WATERFRONT STATION

SECOND STAGE PUD APPLICATION

REVISIONS PACKAGE

MAY 13, 2014

REVISED
PLAN - PENTHOUSE
WATERFRONT 1001 4TH STREET, LLC

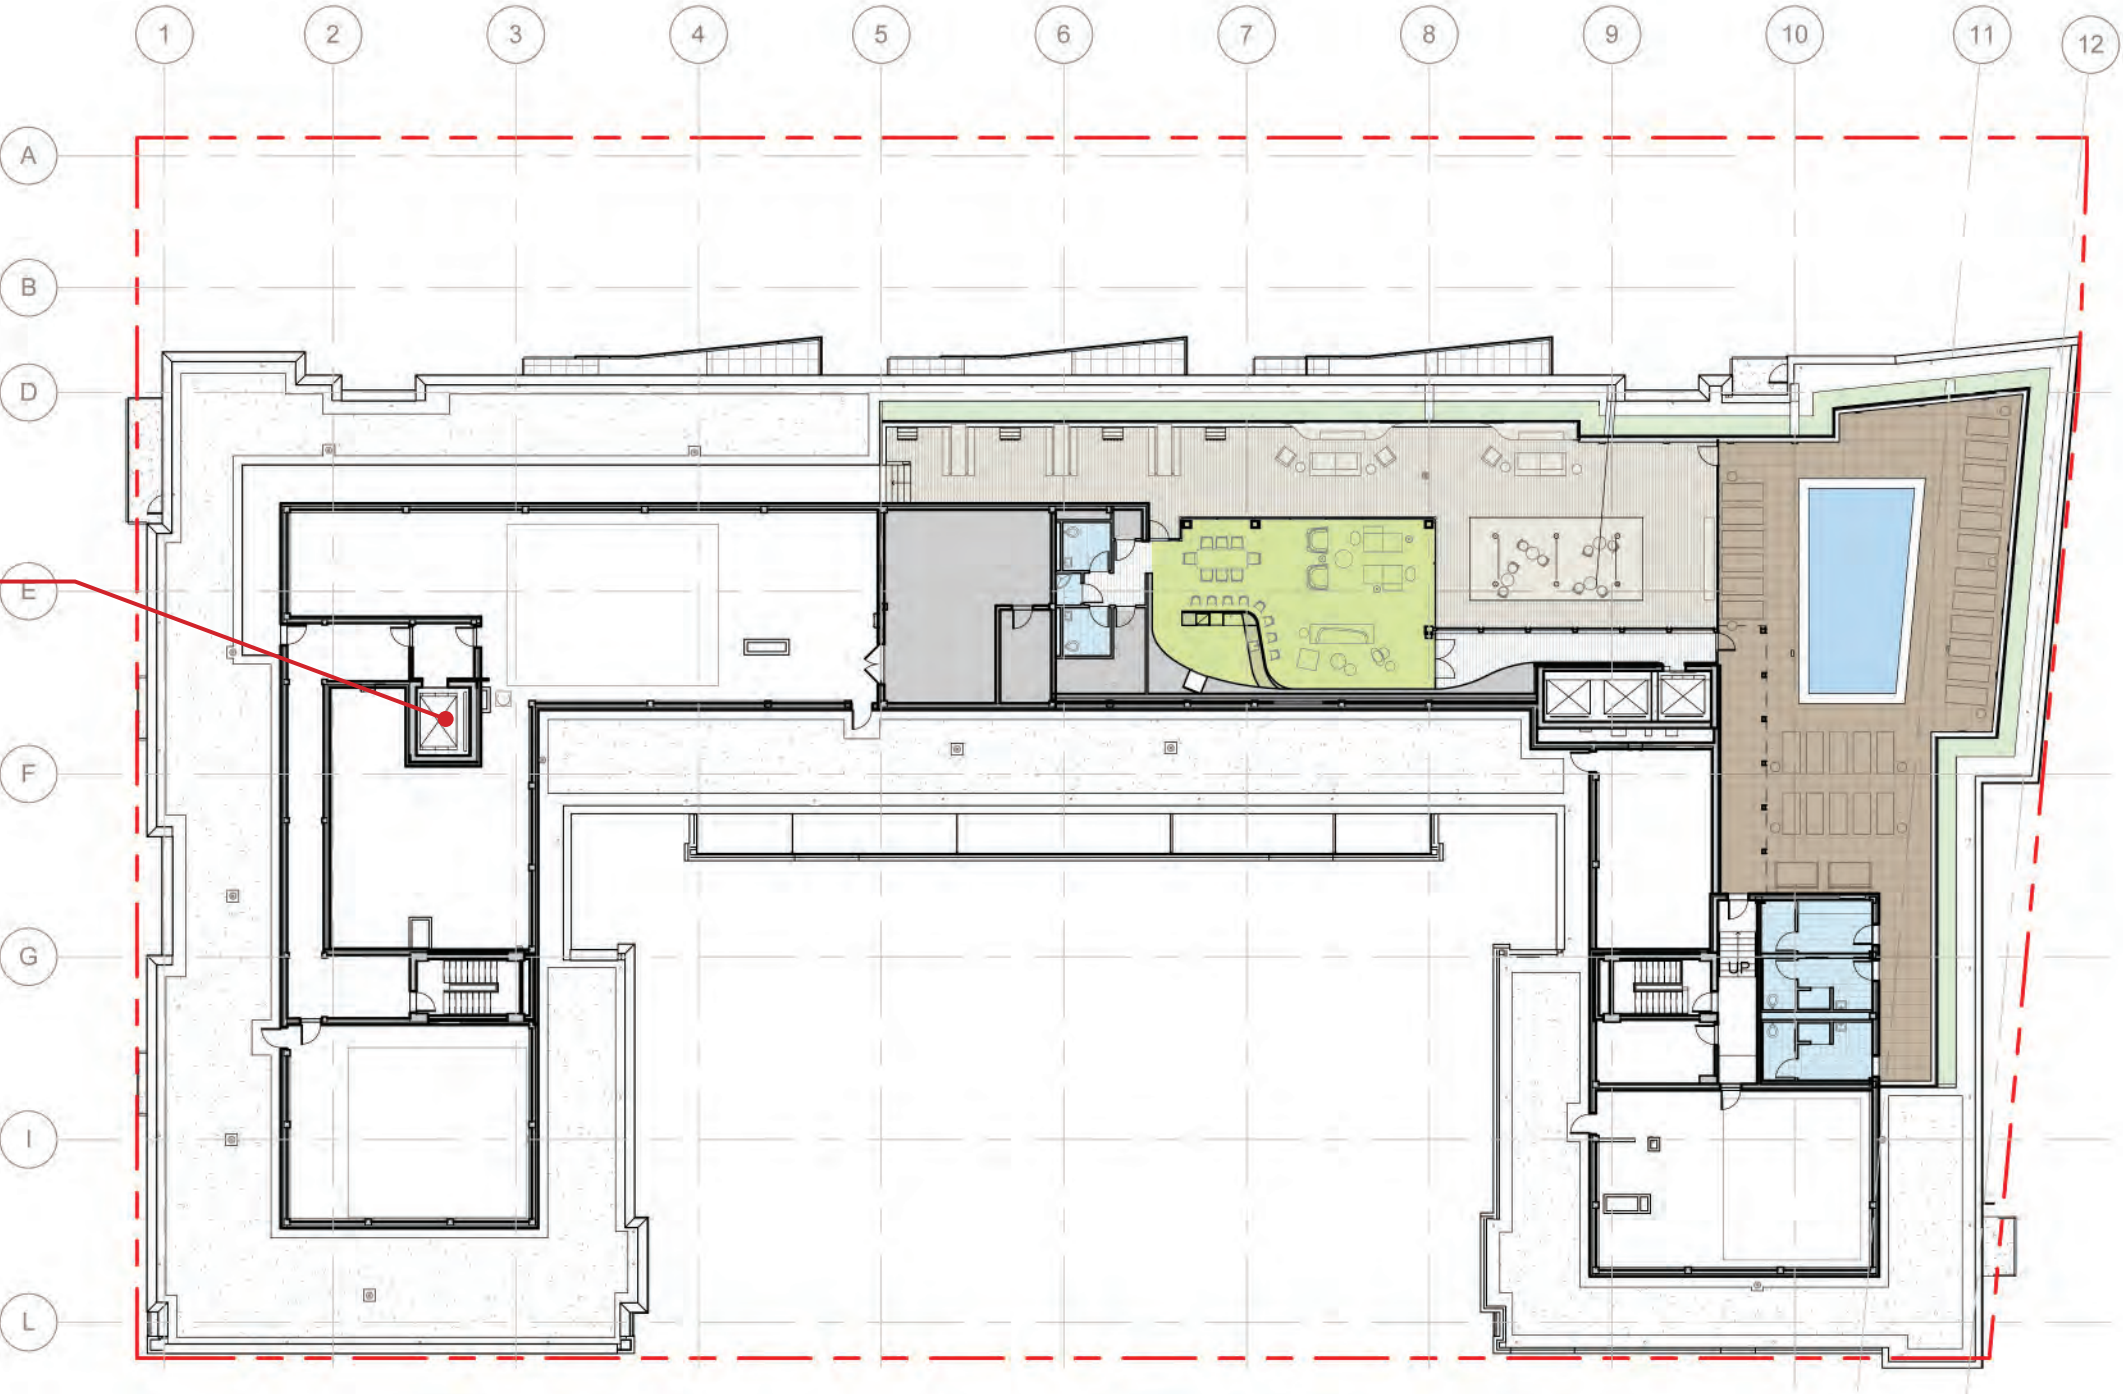
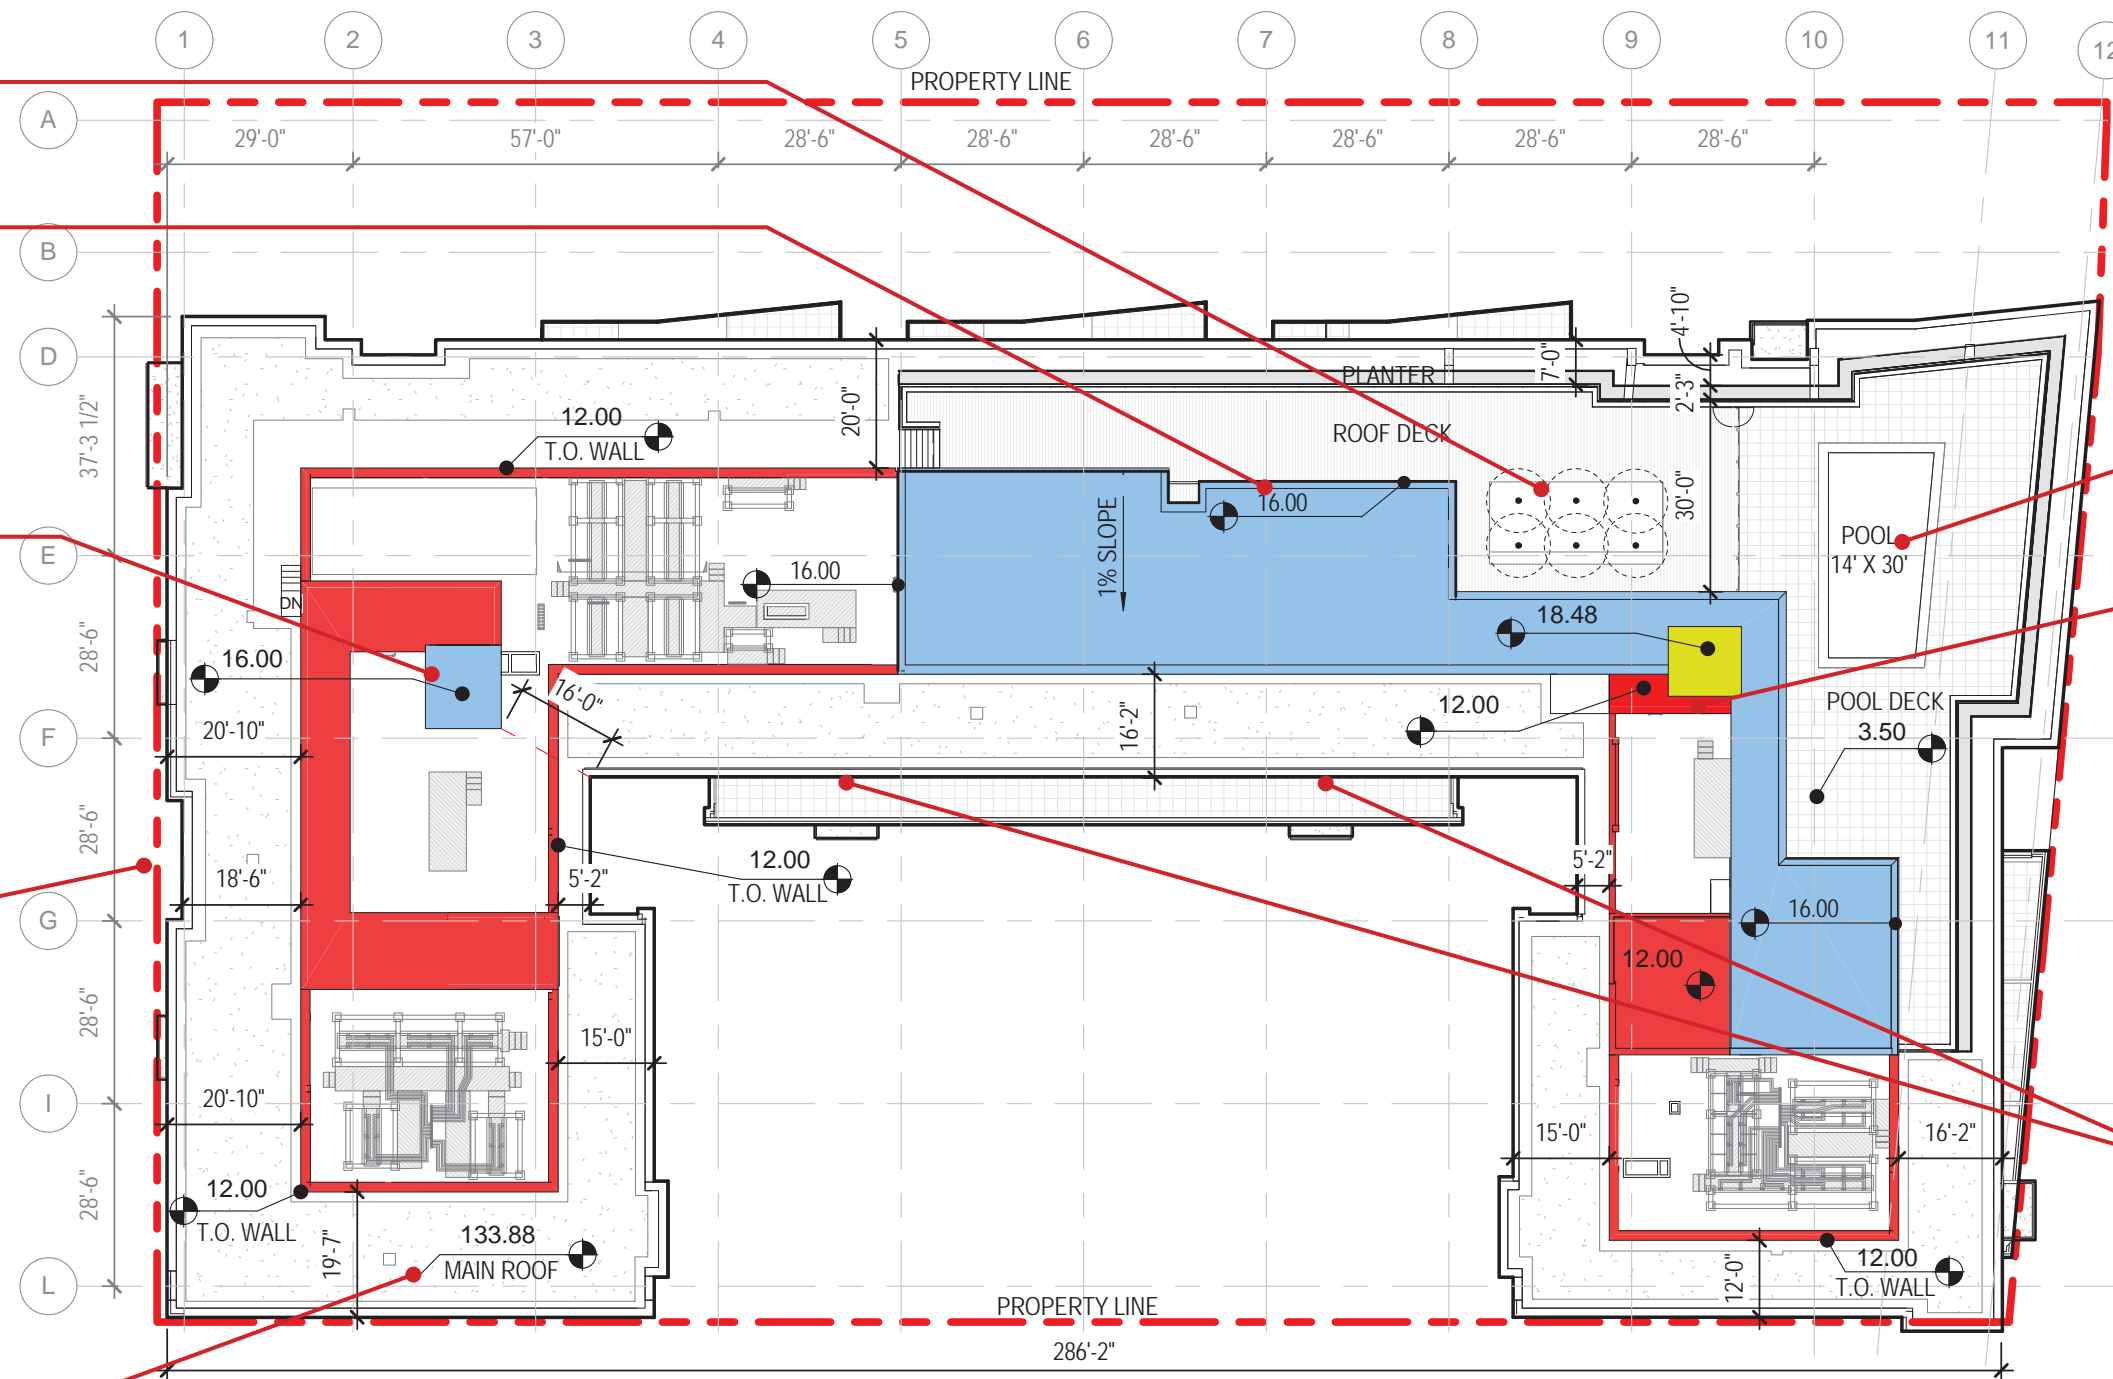
rooftop tree grove consisting of (6) trees added at pool deck level

community room north wall straightened to coordinate with interiors redesign

additional 4'-0" of height required for overrun of previously indicated elevator. Top of elevator at 149.88' (16'-0" above roof)

notch in building moved north 8'-2" to coordinate with interior unit redesign

notch in building terminated below roof to coordinate with south elevation at east wing

pool moved north 14'-4" to improve clearance and access around all sides of pool basin

roof footprint adjusted to accommodate elevator overrun below

bump-outs @ 11th floor removed
